## Product Change Notification

May, 2015

### 8100 Common Mode Choke Series Shipping Package Modification & Order Quantity Adjustment

*Figure 1*

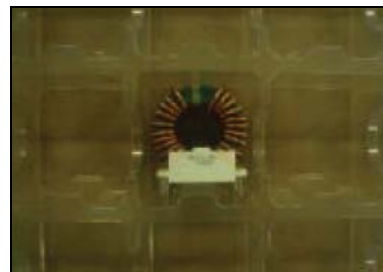
The shipping package of the Bourns® [Model 8100 Series](#) Common Mode Chokes has been redesigned to provide better component protection for normal shipping and handling environments. The original shipping package (Figure 1) offers more limited protection for the components against shock and vibration commonly encountered during shipping and handling processes than the new modified package.
